THREE MILE ISLAND-1

SITE PROBLEM REPORT

CUSTOMER	MET ED	CONTRACT NO.	620-0002	SPR NO.	322	REV. NO.	1
VENDOR	EMCO	P.O. NO.		TASK NO.	21	GROUP NO.	01
SITE ENGINEER	B. P. MAINCI			REQ'D. RESOL. DATE		REQ'D. COMP. DATE	
TITLE LOW PRESSURIZER LEVEL FOLLOWING REACTOR TRIP							
DESCRIPTION OF PROBLEM SEE ATTACHED SHEET							
STATUS - ACTION TO DATE INCLUDING PERSONS CONTACTED L. M. Koleny of Engineering informed.							
FURTHER ACTION RECOMMENDED BY SITE PERSONNEL Review and implement Logic modification such that reactor trip should block calibrating integral RC 9.12, to achieve a slower cooldown rate of RC System and a more acceptable pressurizer level. This problem should be reviewed for all other sites.							
SPOKESMAN		10/4/74	SPOKESMAN SIGNATURE		10/4/74		
RESOLUTION SEE COMPLETION REPORT							
APPROVED BY			SIGNATURE	DATE

TITLE ICS PERFORMANCE FOLLOWING GENERATOR-REACTOR TRIP

FEEDWATER PUMP SPEED "KICKER"
MODIFICATION TO THE ICS

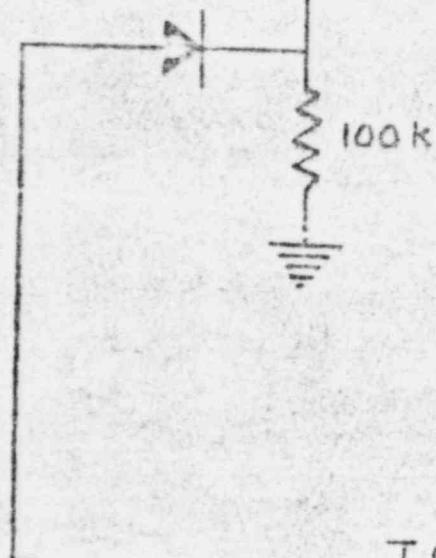
Route an additional wire from the turbine header pressure error signal (IC/B on Drawing Unit #1) to two summers which are shown on Drawing D8032313F. The particular summers are FW28.8B(6-1-3) and FW28.12B(6-2-1) and the new signal is to be connected to each summer. In the new line also install a diode and a 100 k ohm resistor in a path to ground. Refer to the attached schematic.

The turbine header pressure control error signal has the following effective range:

+ 10 Volts = 300 psi above setpoint.
+ 0.5 Volts = 15 psi above setpoint.

Any signal below 0.5 Volts will be blocked by the diode in the new line.

The gain for the turbine header pressure error signal on each summer will have to be calculated and set by Duke Power Company. The calculation used at TMI-1 is given below:

1. Assume pump discharge pressure varies with the square of pump speed when suction pressure is constant.
2. For two feedwater pump operation find the pump speed (S_1) when the plant is at 100% power.
3. This speed corresponds to a turbine header pressure of 885 psig.
For a turbine header pressure of approximately 1050 psi the required pump speed would have to be: $(S_1) = (S_0) \sqrt{1050 + 885}$. The increase in pump speed ($S_1 - S_0$) represents a fraction of the total range of feedwater pump speed (2700 rpm to 5400 rpm at TM-1) and the output voltage of each summer should be adjusted to cause an increase in feedwater pump speed to (S_1) when the turbine header pressure error signal corresponding to 1050 psig occurs on each summer.

REMOVE BIAS SIGNAL ON
PIN 14 OF 6-2-1 COMING
FROM MODULE 4-10-9
PIN 4 AND RE-CONNECT
IT THROUGH A 1 MEG
OHM RESISTOR TO PIN
21 ON MODULE 6-2-1.

Part of Dwg
 D.553730
 Alternative TB control
 using STM 6011, press,
 Danner BMEZER 25T

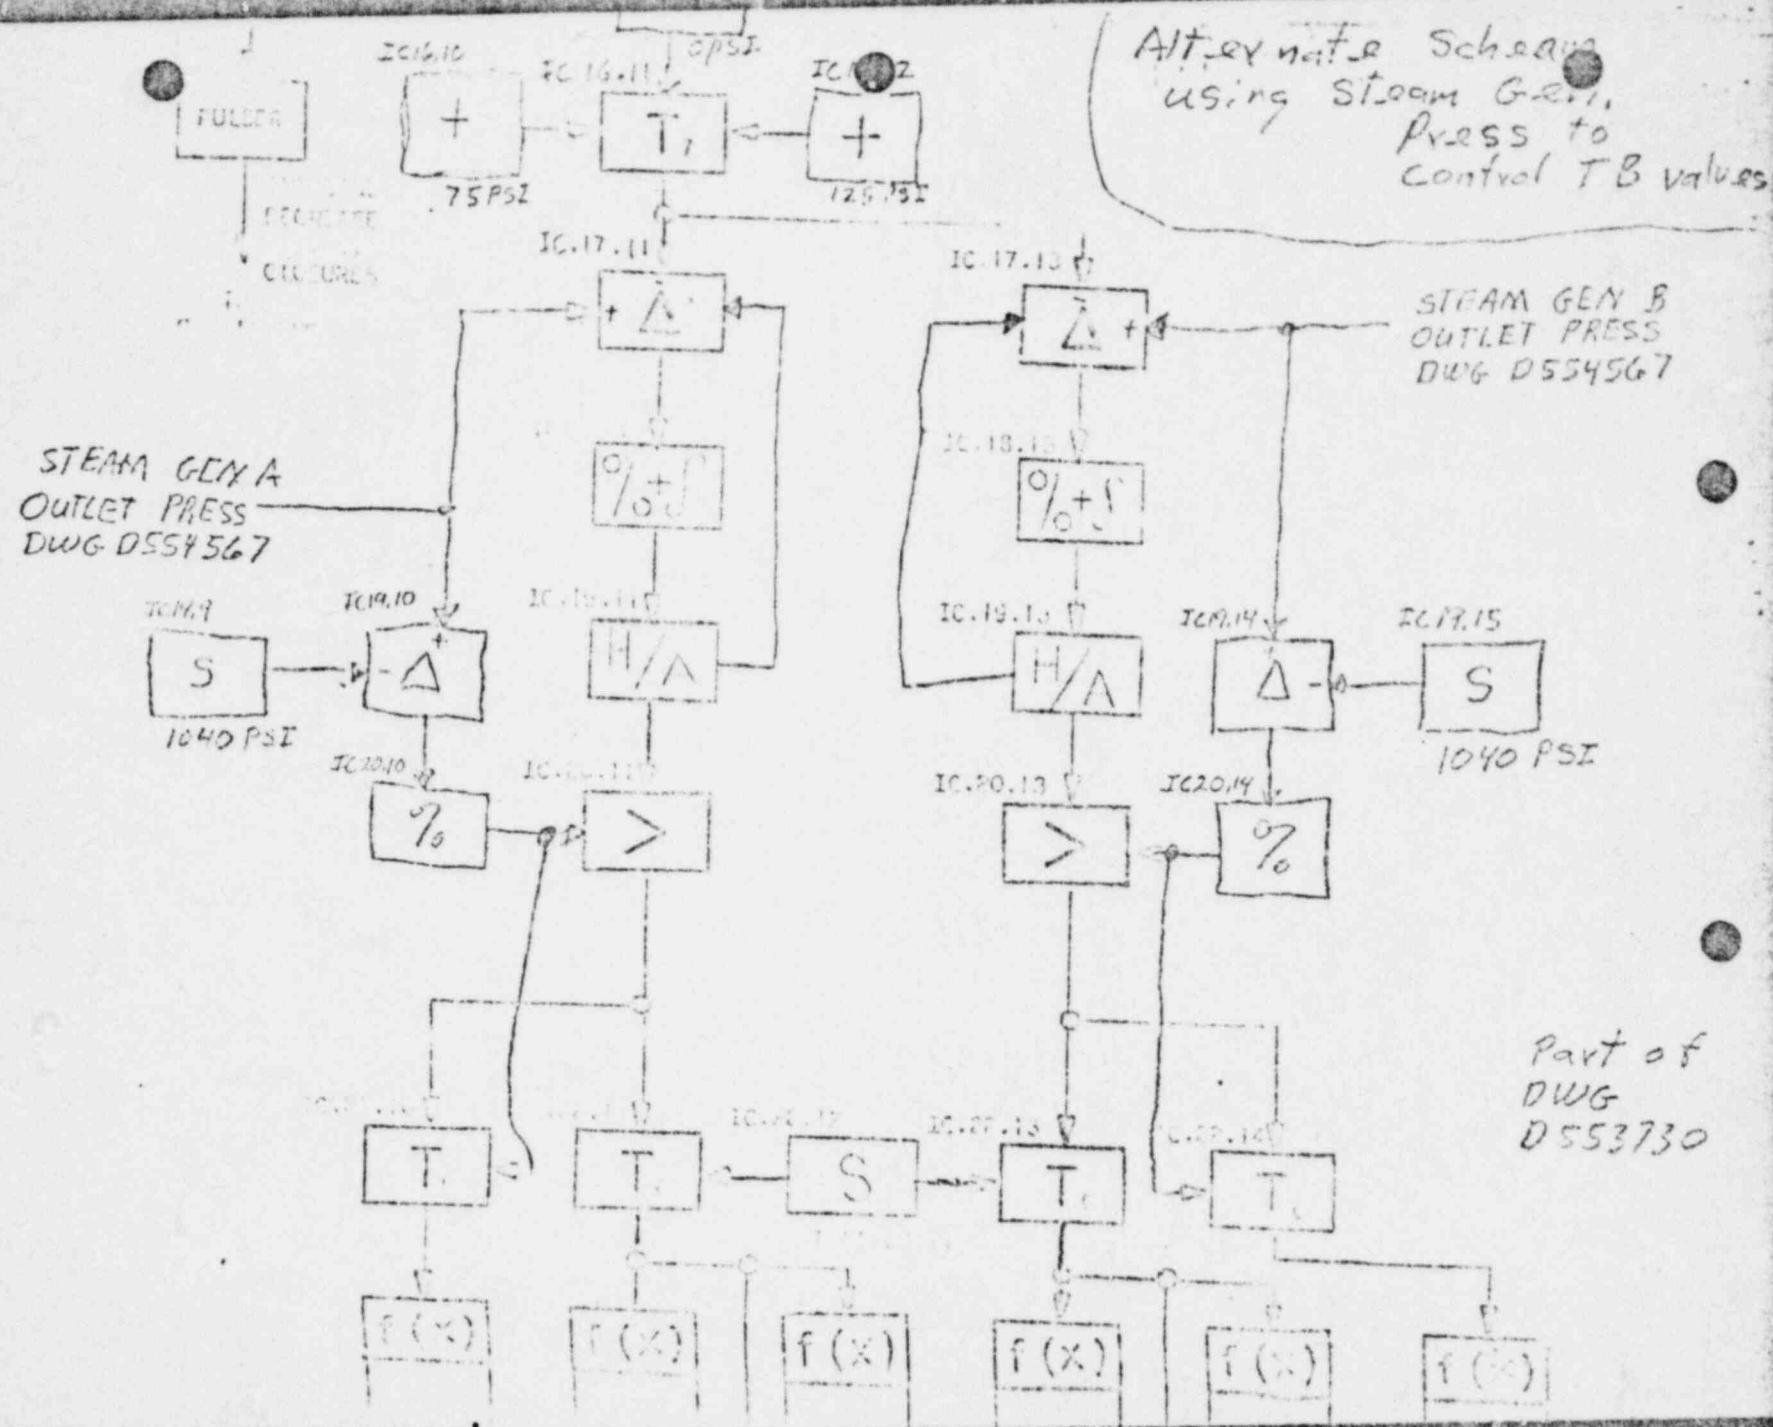
It is believed that this area could be improved by having the turbine bypass valves modulate to control Steam Generator pressure when the reactor is tripped instead of turbine header pressure. Getting these valves closed sooner after a trip should keep the Steam generator pressure from dropping so low which would keep the steam generator temperature higher and therefore TAVE. This should then keep the pressurizer level from dropping so low because it would not have to make up as much volume in the RC system.

Rising stem from
pressure to
control TB
valves

Part of
DWG D 553854

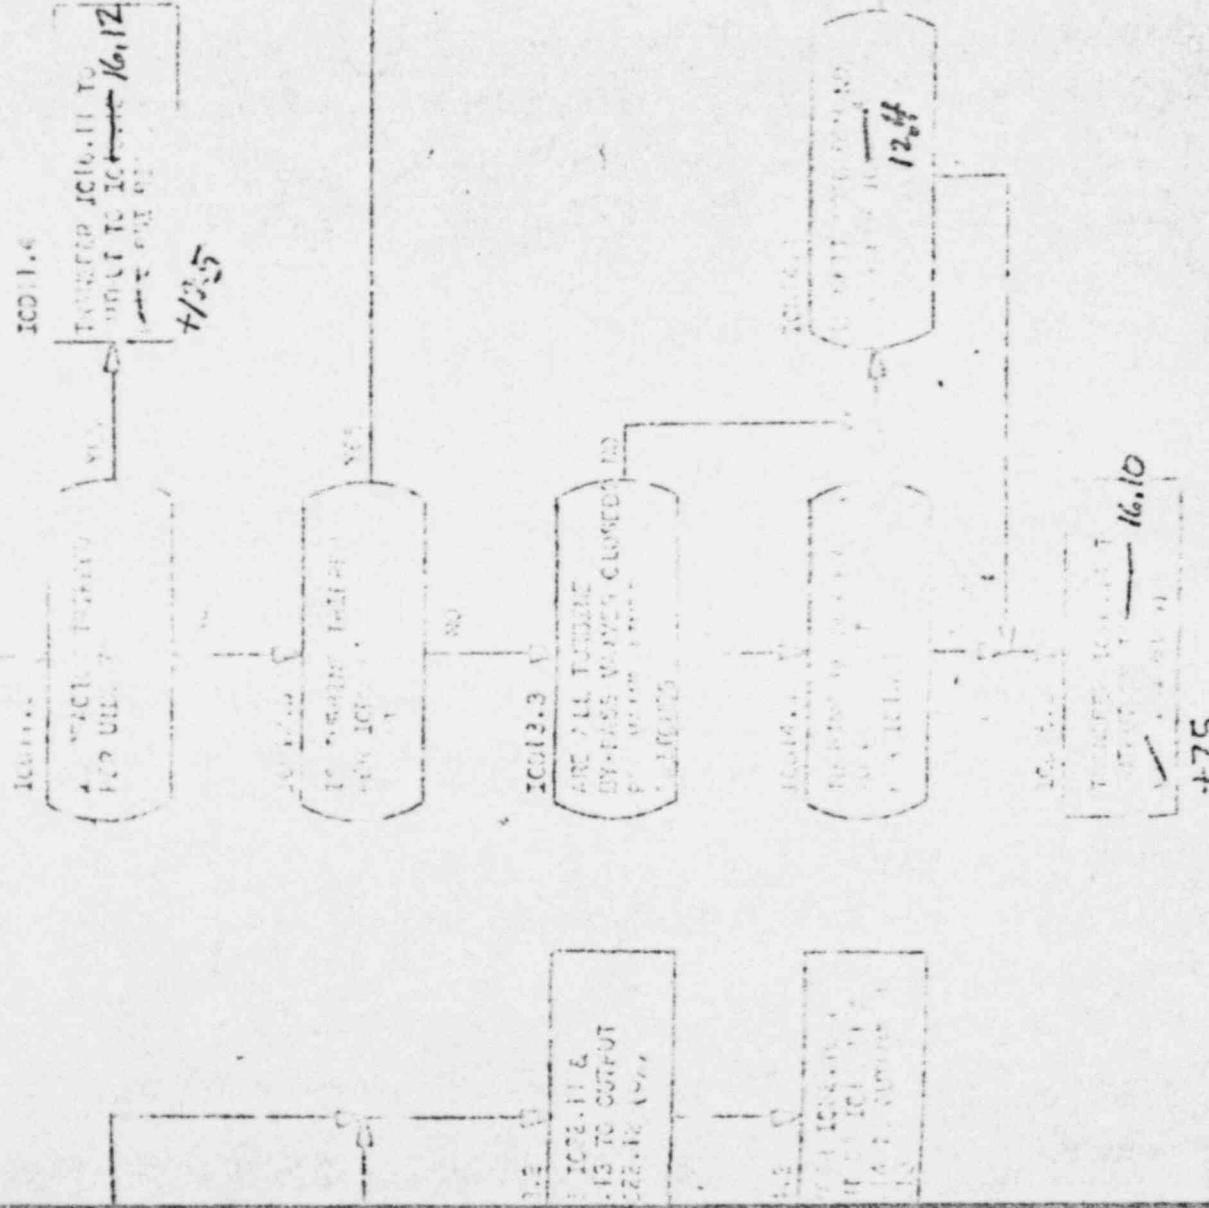
The attached logic and schematic drawings reflect a suggested way to utilize the atmospheric relief valves to open for overpressure at any time, whether the turbine bypass valves are available or not.

It must be considered that this change will substantially increase the use of these atmospheric relief valves and might increase their maintenance requirements.

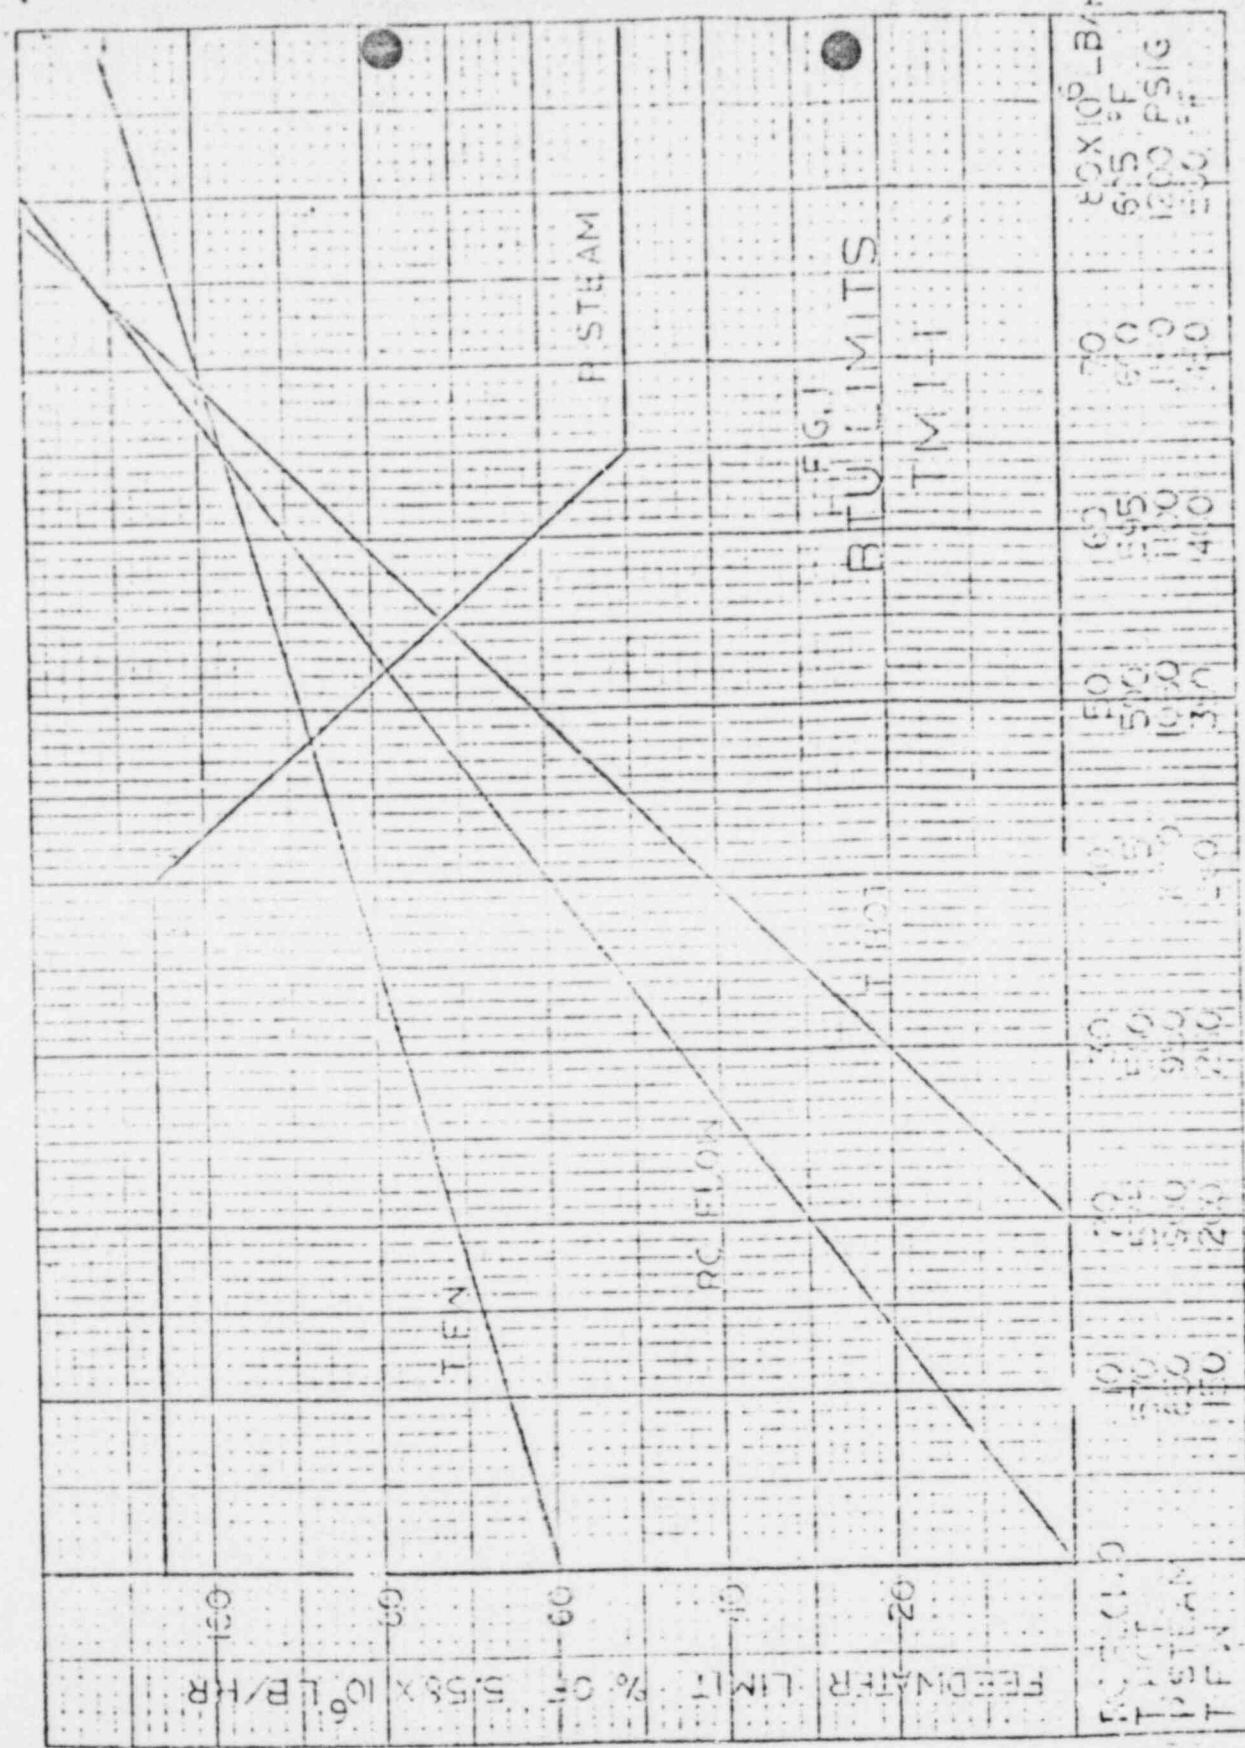
An analysis of plant operational characteristics during the January 23, 1975, power runback transient has led to a revision of the curves comprising the BTU Limit circuit. Figure 1 (attached) shows the revised curves which can be incorporated into the ICS at the first opportunity. Comparison with the curves of Figure 2 which are currently in use reveals that the steam pressure limit is significantly expanded, whereas the T hot curve is more limiting at lower temperatures and power levels. The feedwater temperature curve was changed to properly represent the effect of feedwater temperature on feedwater flow and steam superheat. Also, reactor coolant flow has been changed slightly. These revised curves are to be utilized for all plant operation from now on and are not only associated with the proposed plant runback tests.
